# PacifiCorp - Stakeholder Feedback Form

## 2019 Integrated Resource Plan

2019 Integrated Resource Plan

**SIERRA CLUB'S COMMENTS ON PACIFICORP COAL ANALYSIS METHODOLOGY**

**Figure 1. Projected Battery Capital Cost Declines Relative to 2018, PacifiCorp and Lazard**

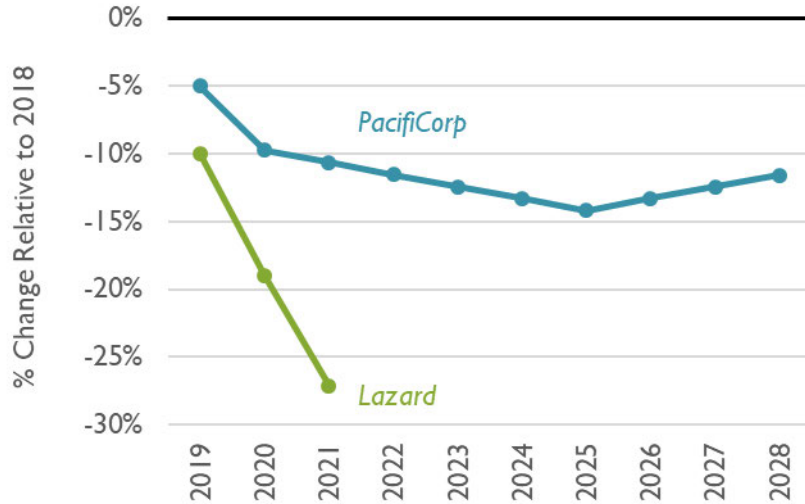
PacifiCorp's assumptions for the current and future capital costs of battery storage resources are too high. PacifiCorp's capital cost trajectory for one megawatt (MW) lithium-ion batteries starts between \$682 and \$1,308 per kilowatt-hour (kWh), depending on the MWh size of the battery.<sup>6</sup> In contrast, the latest industry-standard levelized cost of storage report from Lazard indicates current lithium-ion capital costs of approximately \$500 per kWh.<sup>7</sup> PacifiCorp's estimates are about 35 to 160 percent higher than Lazard's estimate.

Furthermore, PacifiCorp uses low estimates for future battery storage cost declines. The Company assumes annual declines of about 5 percent in 2019 and 2020, followed by cost declines of one percent per year in following six years and then cost increases starting in 2026.<sup>8</sup> Lazard, on the other hand, forecasts lithium-ion capital cost declines of about 10 percent per year between now and 2021.<sup>9</sup> Thus, between 2018 and 2021 Lazard expects lithium-ion costs to decline by about 27 percent whereas PacifiCorp assumes that battery costs will never be more than 14 percent lower than they are today (see Figure 1).

PacifiCorp must review its battery and solar cost assumptions and revise them to be in line with the forecasts of Lazard, NREL, and other independent industry experts. This is an important near-term step, as battery and solar resources constitute potential replacement options for retiring coal capacity.
